Re: Mitchells Corner  
CZ #1967, CZ # 1968, CU #2334  
Sussex County Tax Parcel No. 335-8.00-37.00  
Source Water Protection, Sussex County Code, Chapter 89

Verdantas, LLC (Verdantas) appreciates the opportunity to respond to comments by the Lewes Board of Public Works (BPW) and its consultant Barton and Loguidice, D.P.C. (B&L) concerning the proposed development of the Mitchell Farm Property. As you are aware, a small portion of the Mitchell Farm Property lies within the boundary of the mapped Wellhead Protection Area (WHPA) for the City of Lewes Wellfield, but beyond the incorporated boundary of the City. This letter is in response to comments from BPW and B&L concerning the proposed development of the Mitchell Farm Property and is a further supplement to Verdantas' February 2022 Environmental Assessment Report and April 25, 2022 Supplemental Letter Report.

Figure 1:

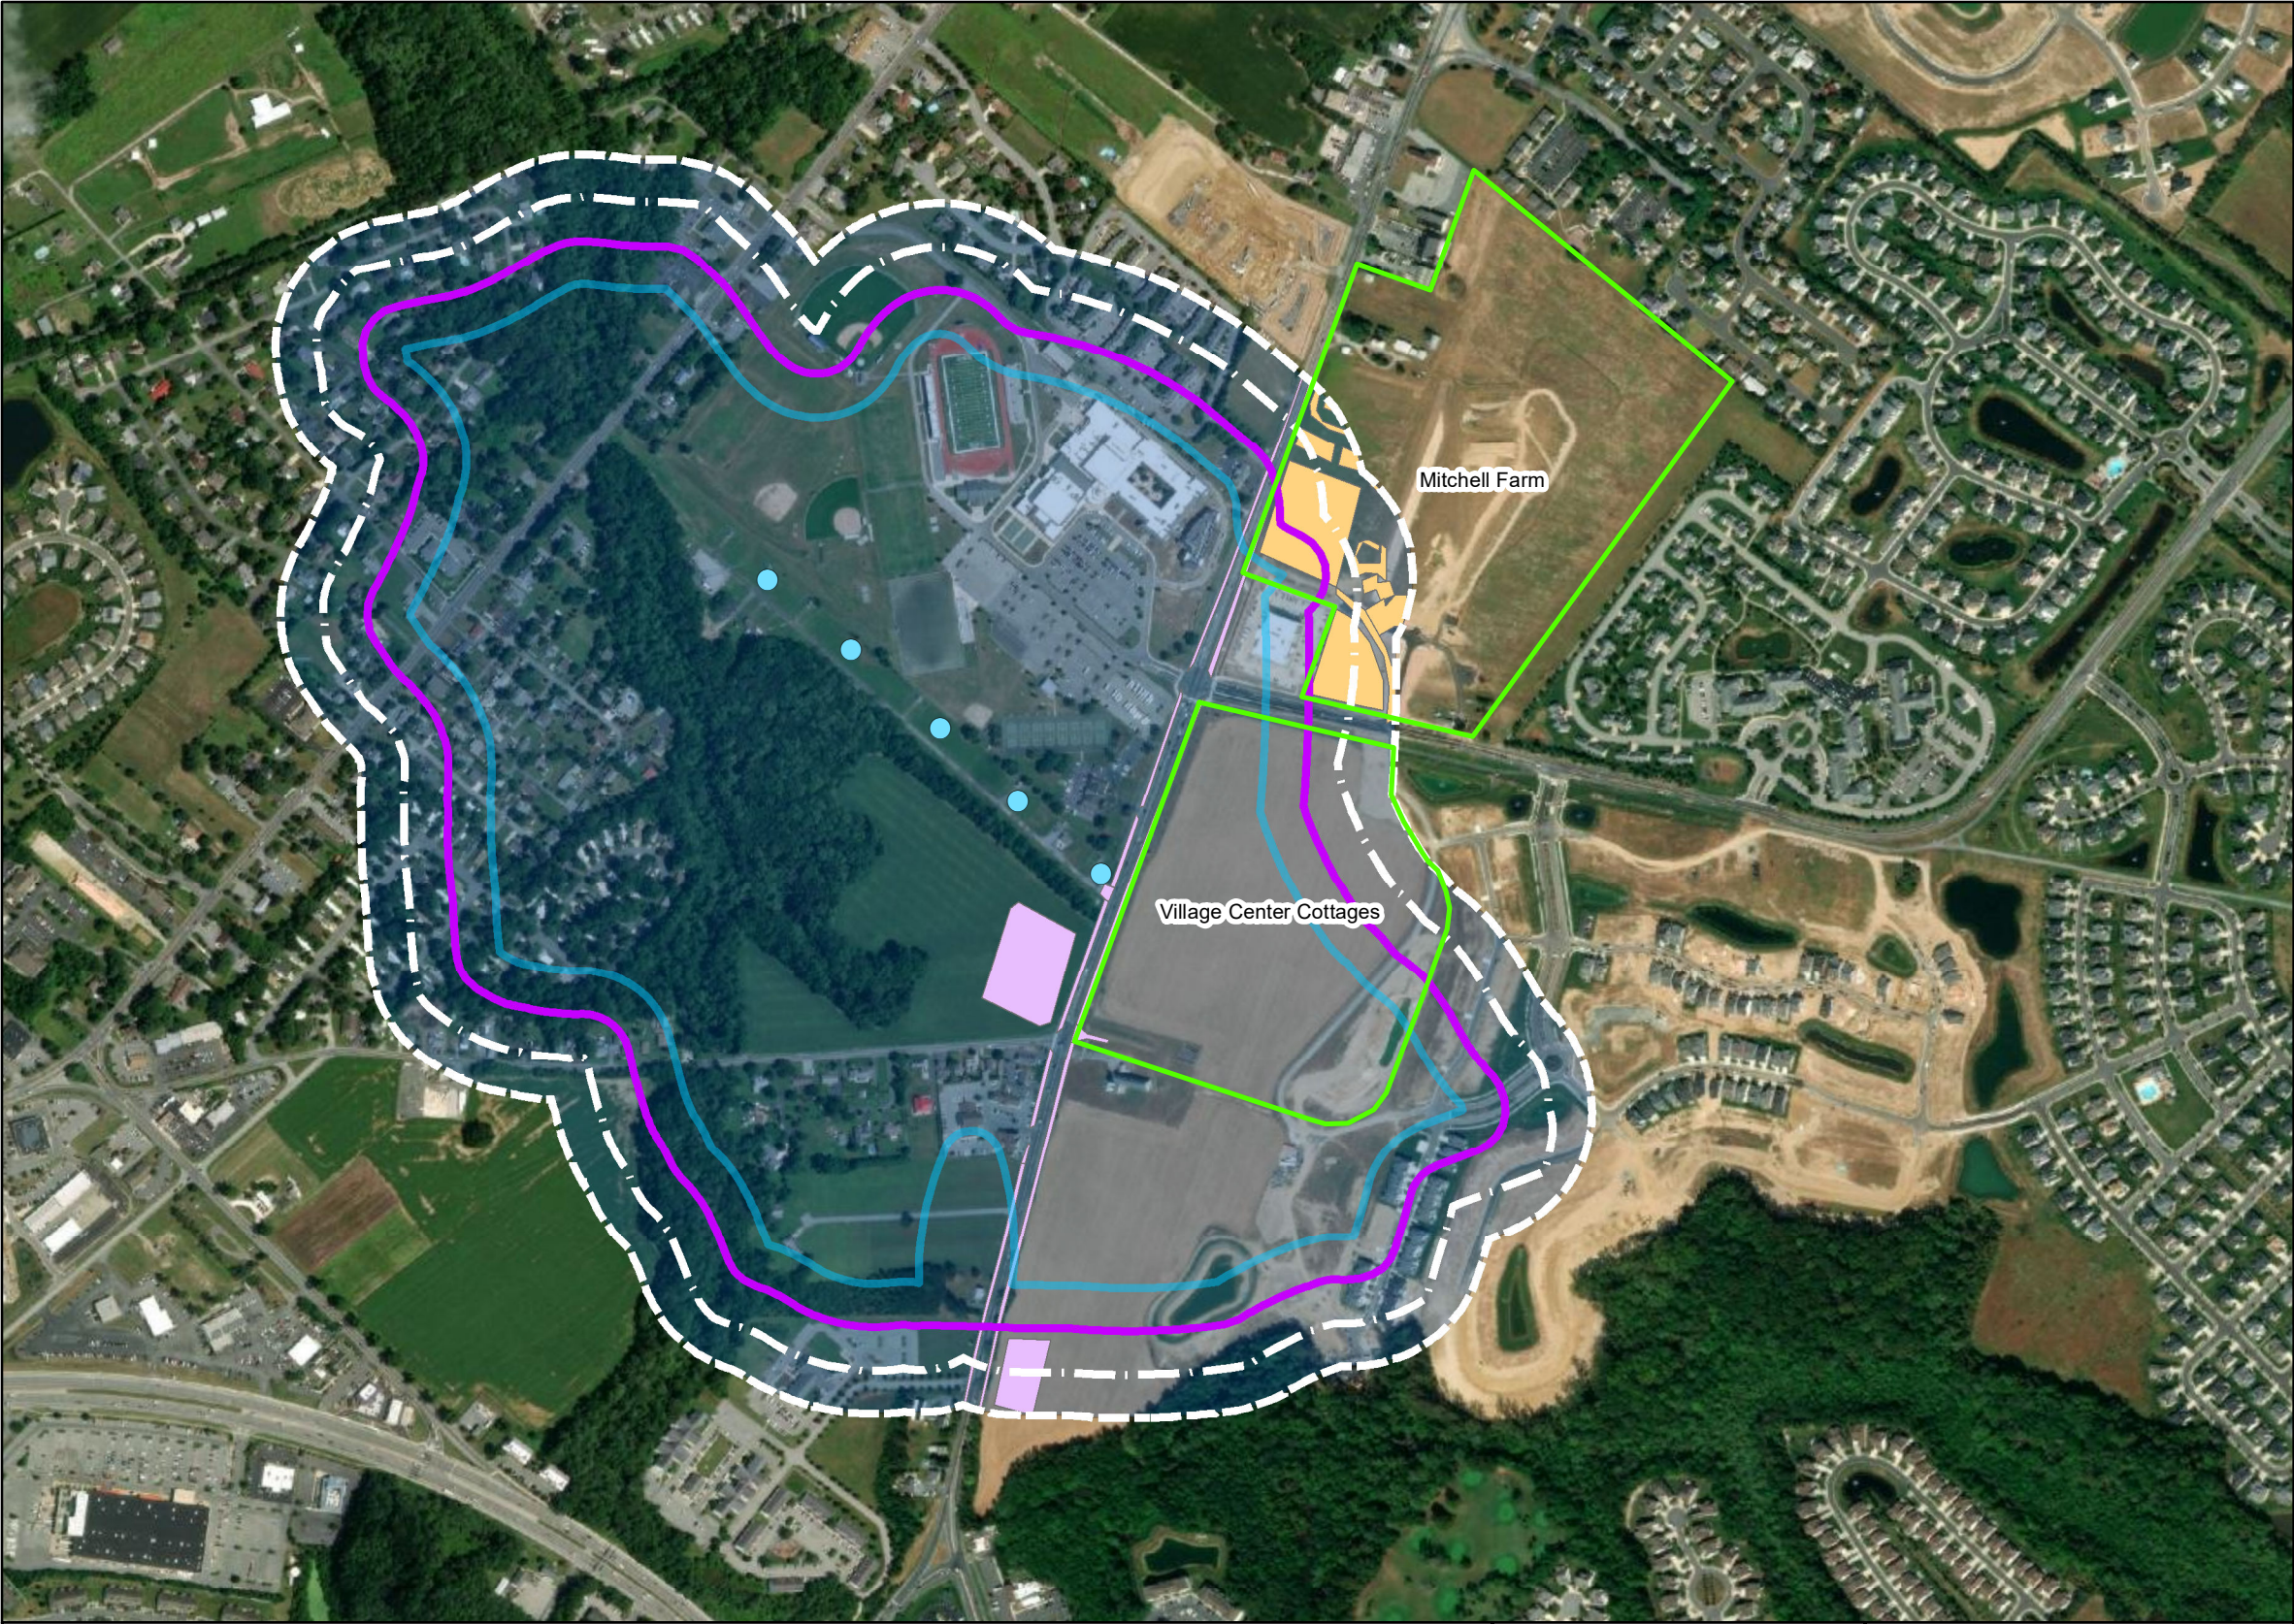
The updated WHPA delineation is not official and merely is offered for illustrative purposes. As is the case with the original DGS delineation, a 100-meter (m) buffer is included in the updated WHPA. The attached figure (Figure 1) outlines the original WHPA and its updated, projected extent to reflect water demand changes. We also illustrate the positions of the VCC, the Mitchell farm and US-9 for context.

The updated WHPA delineation is not official and merely is offered for illustrative purposes. As is the case with the original DGS delineation, a 100-meter (m) buffer is included in the updated WHPA. The attached figure (Figure 1) outlines the original WHPA and its updated, projected extent to reflect water demand changes. We also illustrate the positions of the VCC, the Mitchell farm and US-9 for context.

*Response –Ebenezer Branch is located 1,800 feet southwest of the Mitchell Farm, and on the opposite side of the Lewes wellfield. Considering that distance and the substantial surplus in post-development recharge proposed by the Mitchell Farm project, we do not anticipate any interference from the Applicant's property with surface water conditions in Ebenezer Branch. In addition, Ebenezer Branch is not influenced by tide in the vicinity of the wellfield. The extent of tidal influence (and "sea water") does not extend past the dam-like structure located at Donovan's Road, approximately 2,700 feet downstream of the wellfield (Figure 1 attached).*

*The Mitchell Farm property is located approximately 1,800 feet northeast of Ebenezer Branch, on the opposite side of the Lewes wellfield. Considering the distance and position of the Mitchell Farm property in relation to Ebenezer Branch, and the substantial surplus in post-development recharge planned for the property, we do not anticipate activities on the Mitchell Farm property would contribute to potential lowering of the water table in the vicinity of the wellfield or Ebenezer Branch (Figure 1 attached).*
